Product Change Notification

Change Notification #: 104437 - 00
Change Title: Intel(R) TXN181072013 Optical Transceiver, PCN 104437-00, FYI, Modified Mechanical Housing.
Date of Publication: October 01, 2004

XFP housing modification

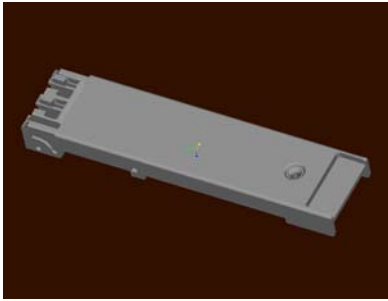
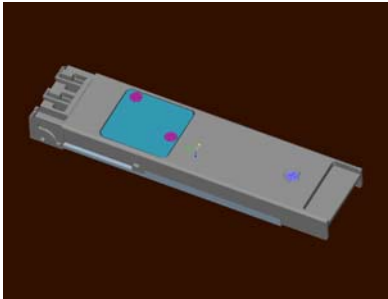
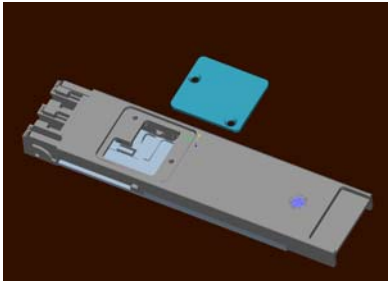
The Intel® TXN181072013 line of Optical transceivers will ship with a modified mechanical housing. No internal modification to the transceiver will be made.

Panel closed after Optics Attach

Panel slightly countersunk to avoid possible contact when inserting module

Panel slightly countersunk to avoid possible contact when inserting module. Panel is closed after Optics attach
